City of San Antonio
TRANSPORTATION AND CAPITAL IMPROVEMENTS

ADDENDUM No. 2

PROJECT NAME: Menger Creek Drainage – ID NO.:40-00328

DATE: August 4, 2015

HYDRAULIC DATA SHEET 1 OF 3
RAILROAD CULVERT

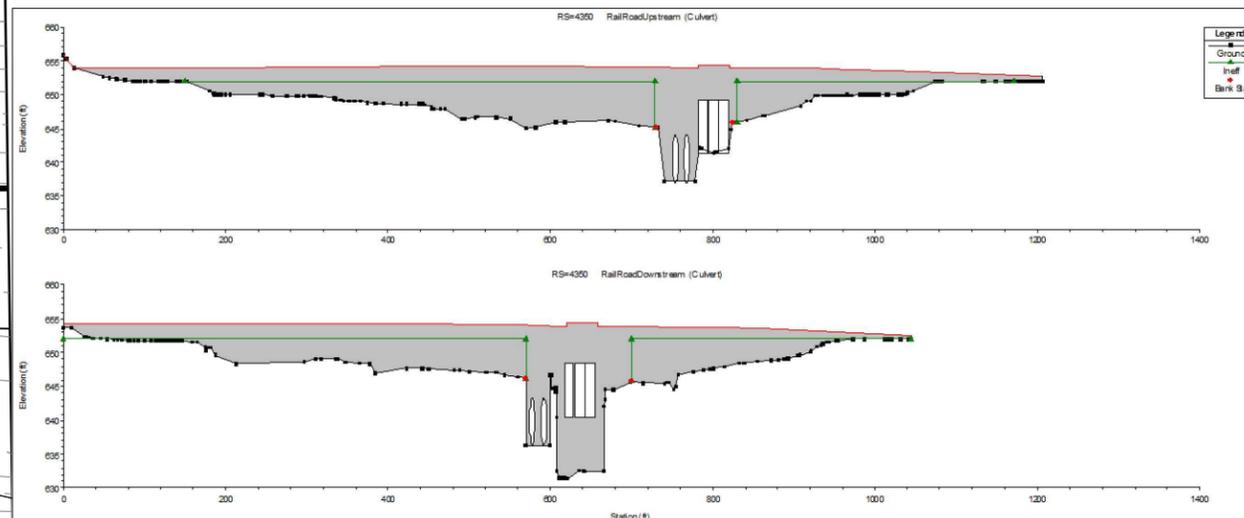
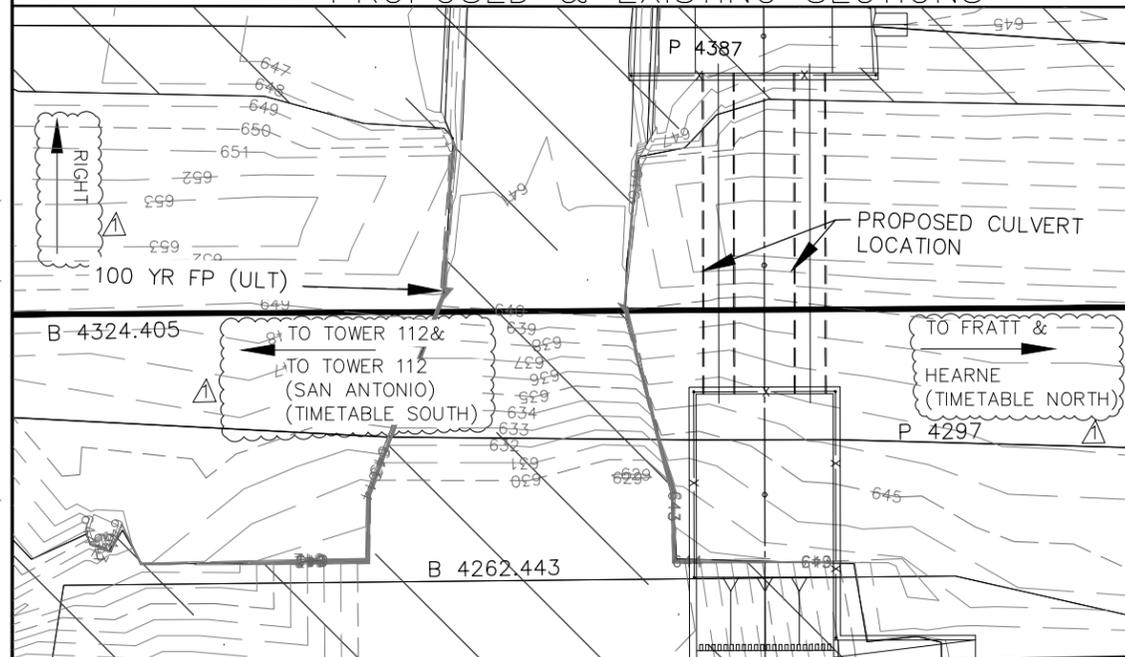
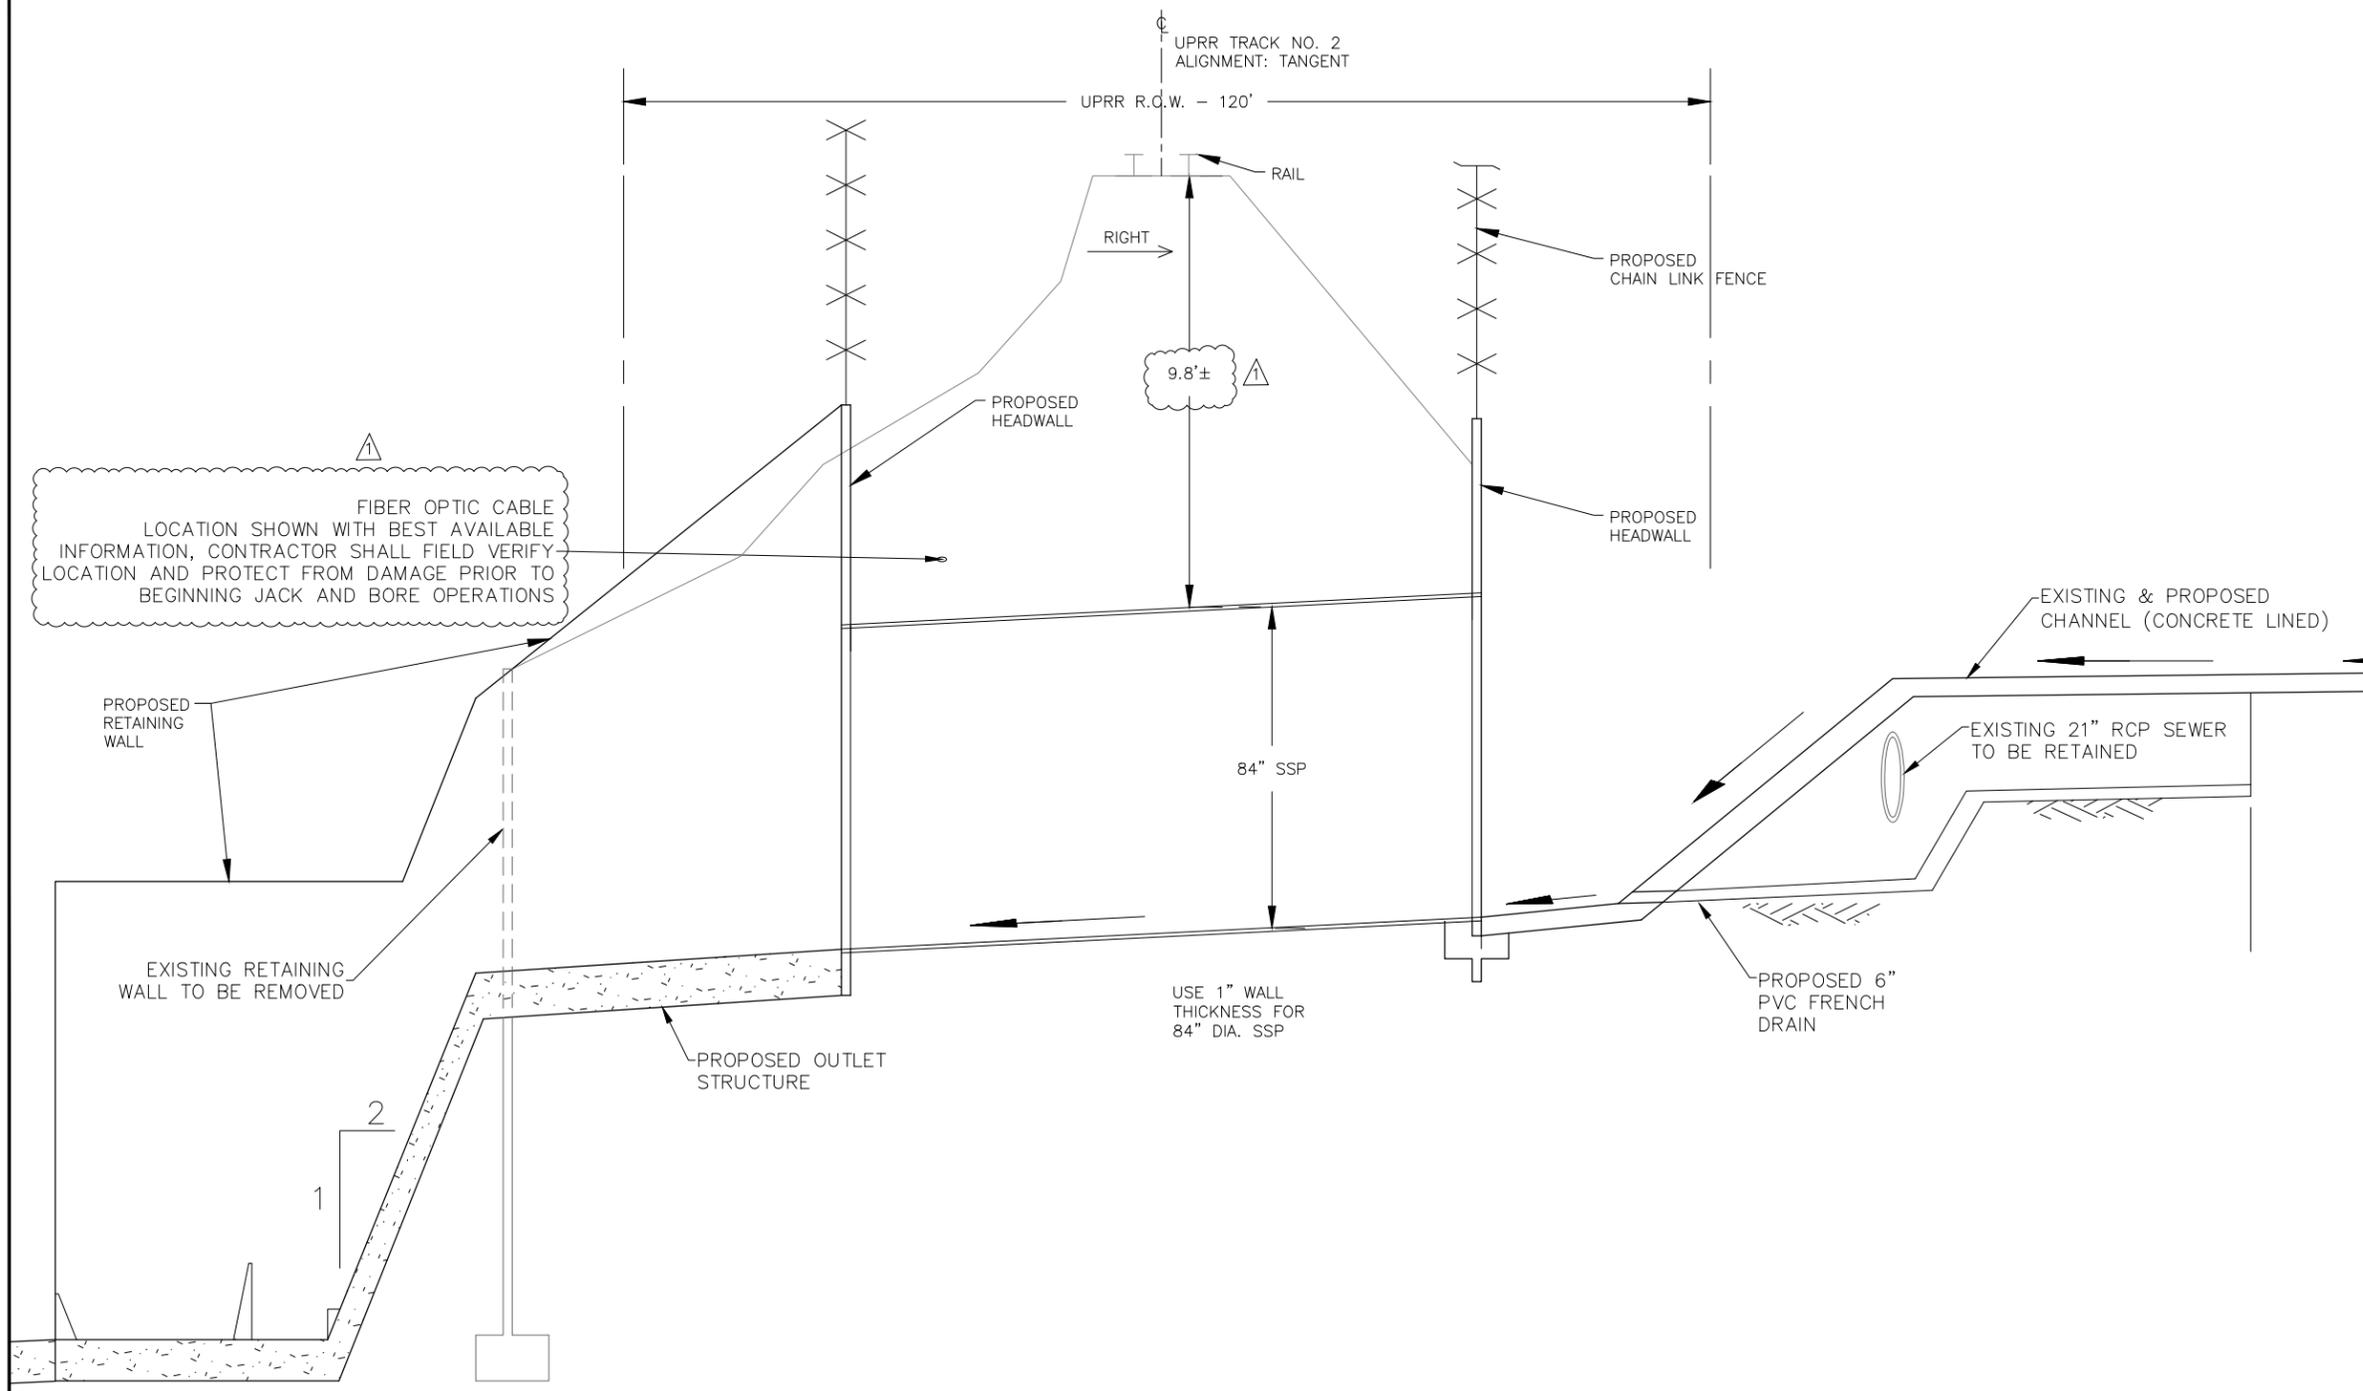
1. The following sheets were revised in the construction plans for the CoSA Drainage Improvements:
 - o C-04 (Quantity Sheet)
 - o C-03 (CoSA General Notes)
 - o C-44 (Hydraulic Data Sheet 1 of 3, Railroad Culvert)
 - o C-82 (Proposed UPRR Typical Section)
 - o C-83 (Additive Alternative Plan, Sta. 0+00 to Sta. 4+99.58)
 - o C-84 (Additive Alternative Profile, Sta. 0+00 to Sta. 3+62.92)
 - o C-86 (Additive Alternative, Enlarged Plan, Sta. 0+00 to Sta. 2+87)
 - o C-87 (Additive Alternative, Railroad Crossing – Section)
2. A Special Specification for UPRR Flaggings (1205) was added to the CoSA Specifications.
3. Bid Form 025 was revised; adding, changing, and deleting several bid items & quantities.

NO.	BY	DATE	REVISION DESCRIPTION
1	PS	8-3-2015	ADD UPRR INFORMATION

MENDER CREEK
 PROPOSED UPRR TYPICAL SECTION

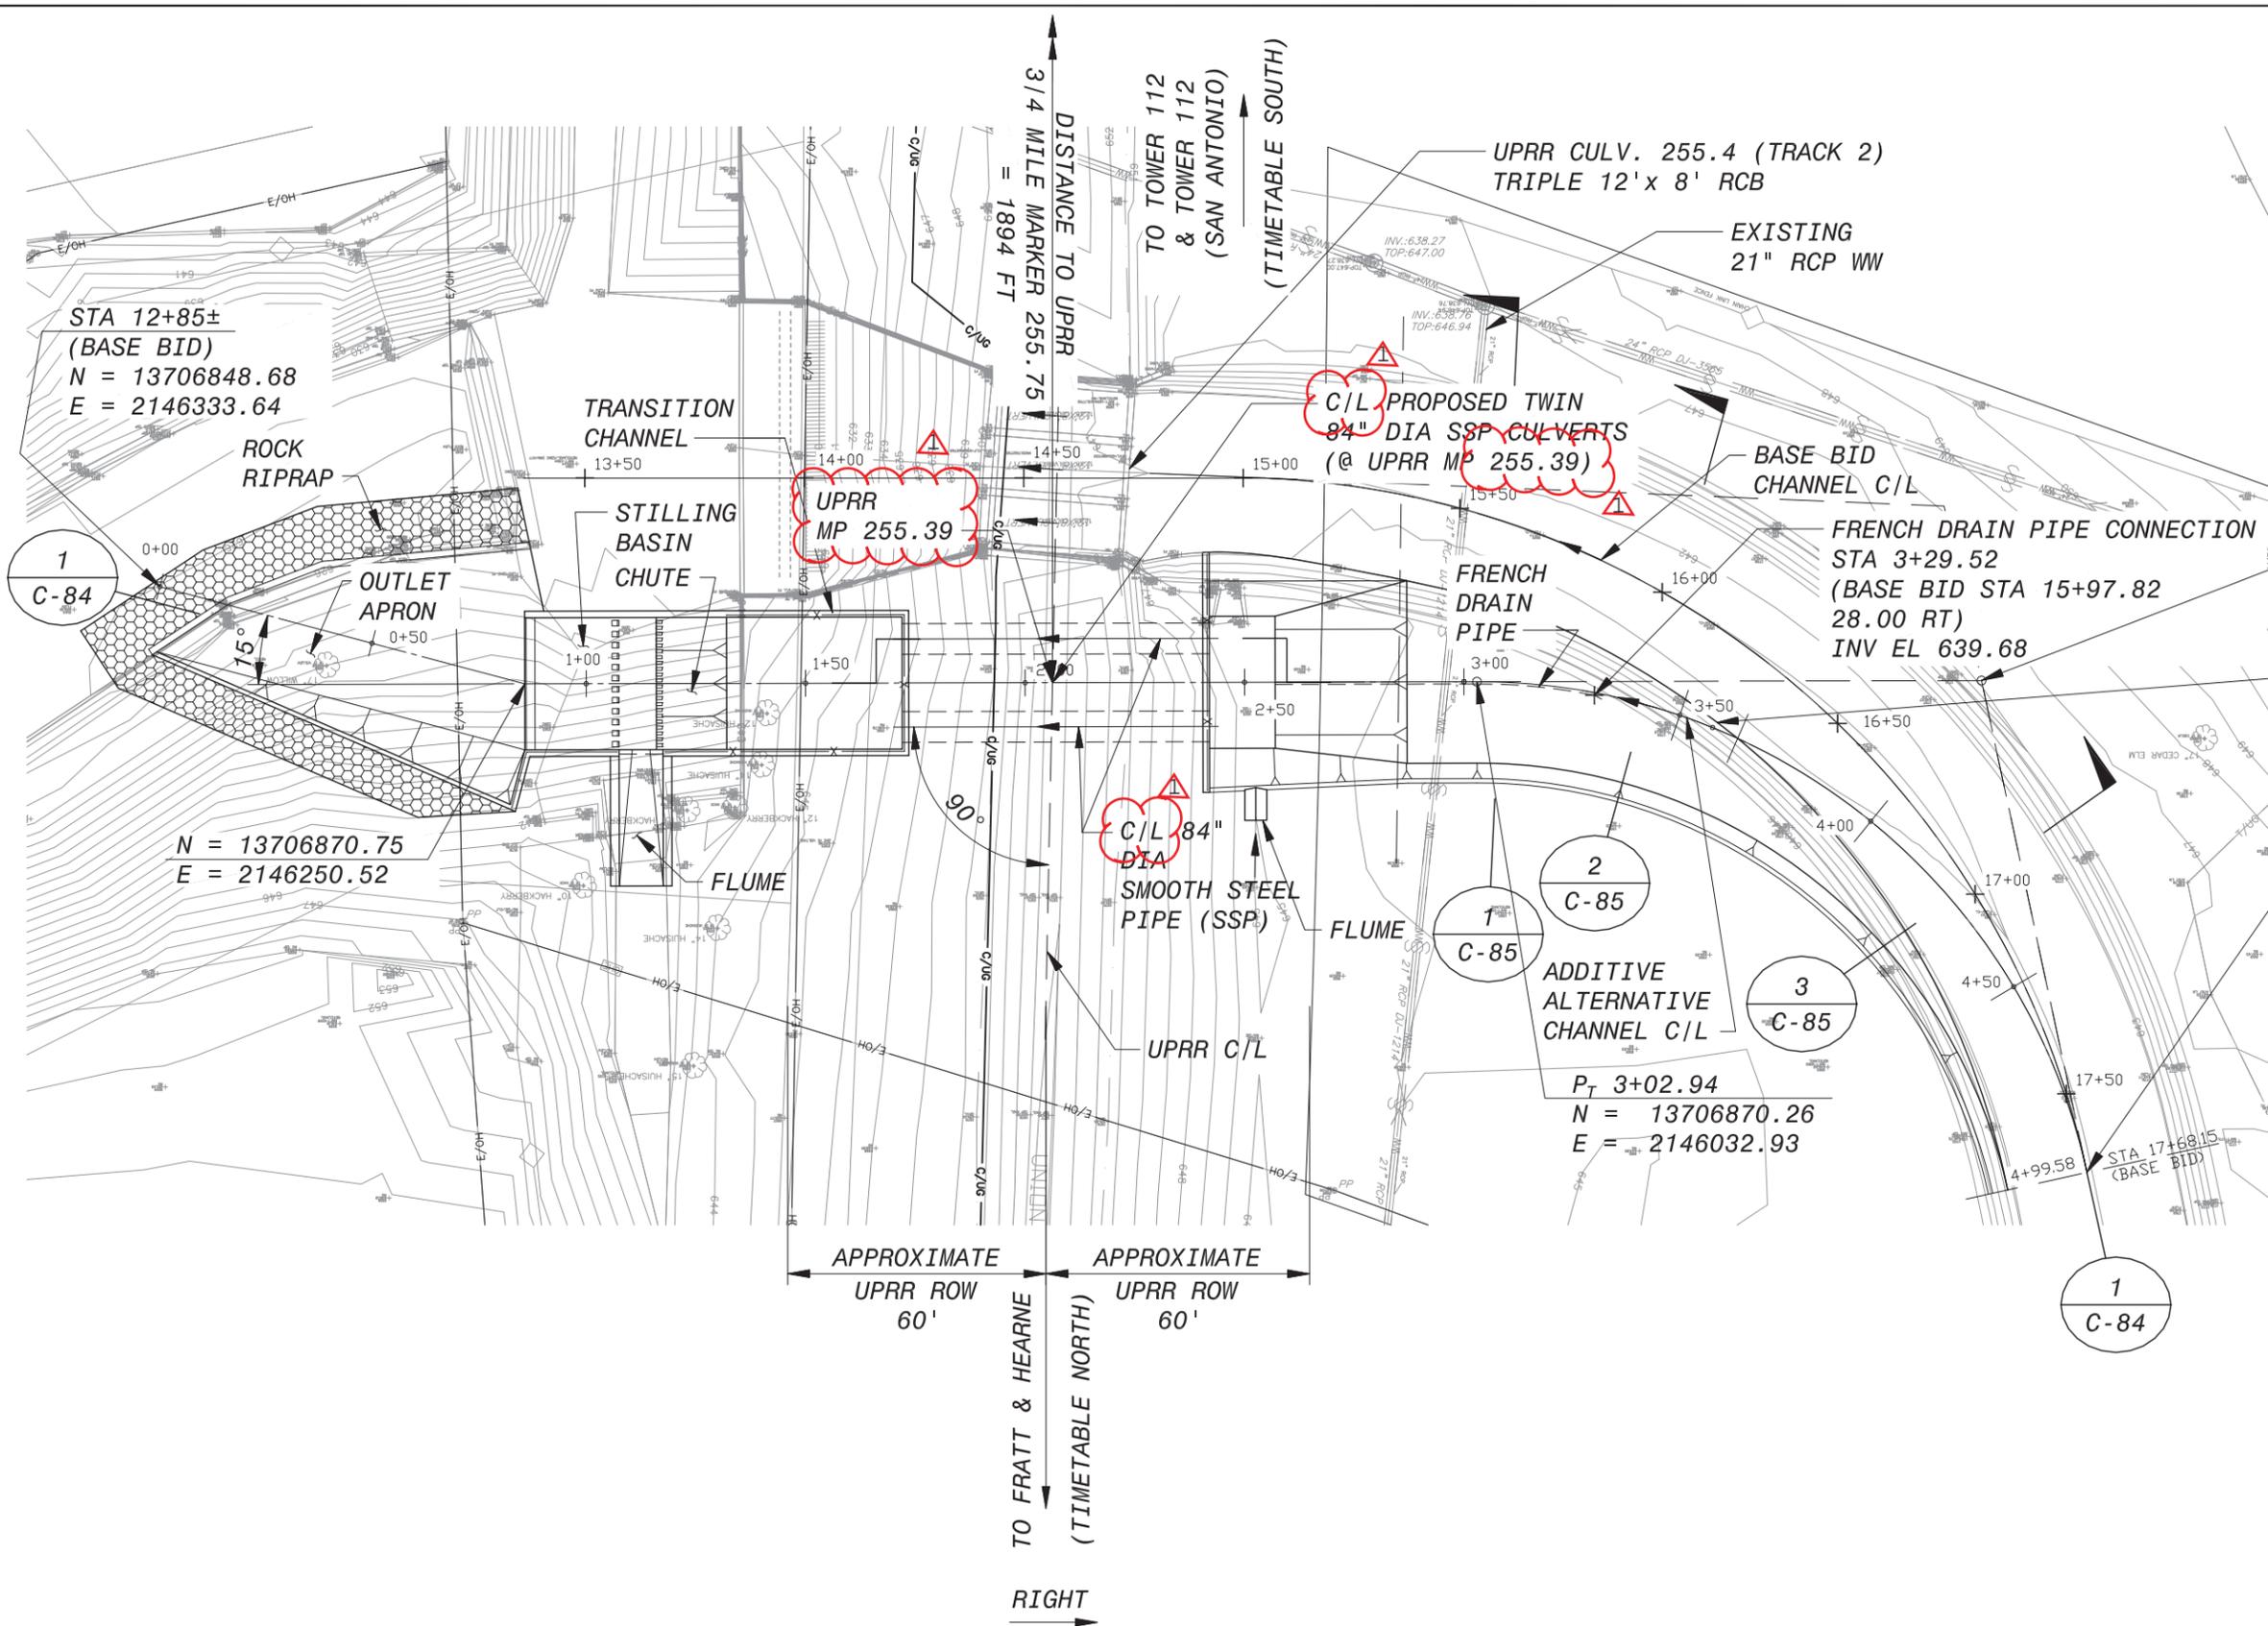
NO.	BY	DATE	REVISION DESCRIPTION
1	PS	8-3-2015	ADD NOTE, CHANGE DIMENSION
